MURRAY CITY CENTER DISTRICT

3. The NOAH - 149, 155-157, and 163 East Vine Street

Vertical Mixed Use Project with 40 Multifamily Units and 2,846 sq ft of Commercial Project #24-078

AGENDA ITEM # 3 - The NOAH

REVISIONS	
INITIAL SUBMITTAL	9/27/2022
1	
DRAWN: JBC	2024-06-24
APPROVED: CC	2024-06-24
PROJECT #:	2065002
2065002 PLANSET.dwg	
C400	
SITE PLAN

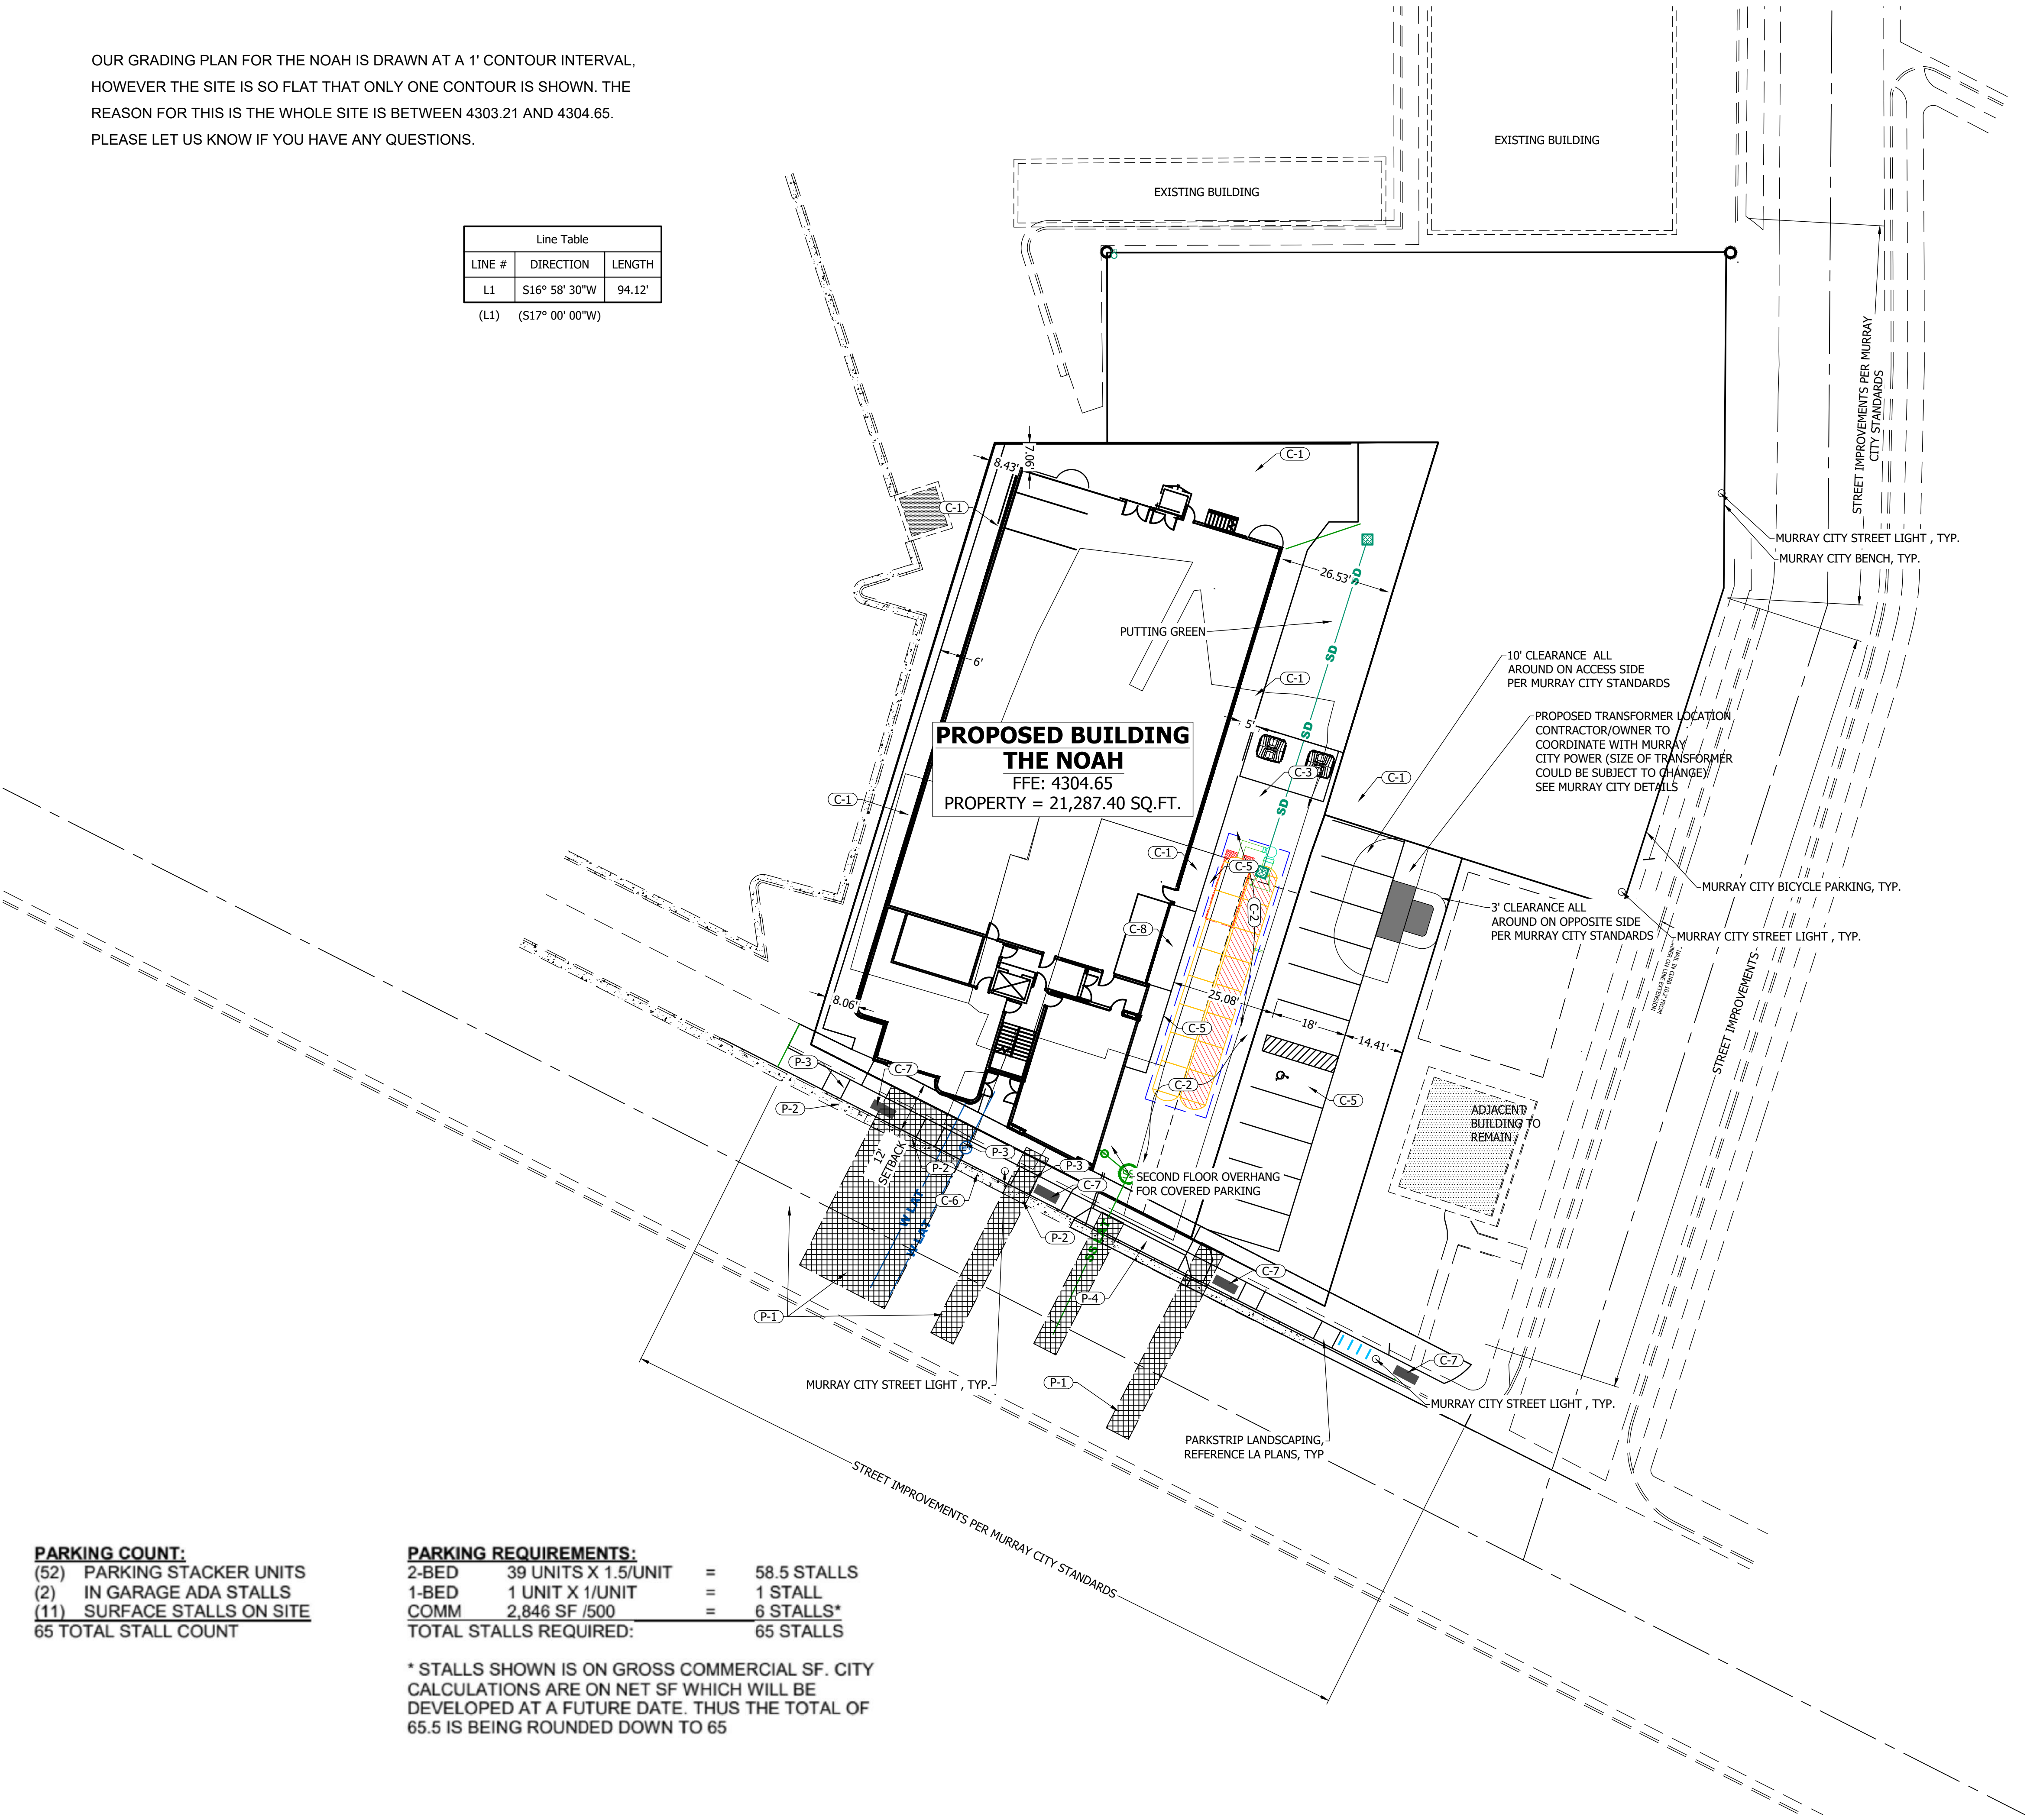
The applicant has not provided a complete curbside management plan. There have been discussions in person about “red-curbing” the front area of the building to not allow for public parking. This has thus far not been shown on any plans. The applicant will need to provide a specific plan that outlines space for loading/unloading for public transit, ridesharing, micro-transit, and accommodation for residential and commercial delivery vehicles.

Within the MCCD Zone there is a bike parking requirement of 5% of the total number of spaces be provided for bicycles. This results in two (2) required spaces. Staff encourages the applicant to provide additional bicycle parking within the structure to facilitate a more bike

Staff has concerns about access to the bicycle storage area. It seems to be placed behind the building with little to no thought given to the potential users. Staff recommends that the applicant review the location of the bike parking and see if it can be placed in a more easily

The use of stacked mechanical parking is unique in this project. It allows the parking area to be smaller than what would normally be required in the zone. However, the number of parking spaces is still inadequate according to the requirements of the MCCD Zone. The applicant will need to work with staff to address this.

1. Prior to being placed on a Planning Commission agenda the applicant shall provide a curbside management plan that addresses the location for ride-share, delivery, and other vehicles used on a temporary basis.
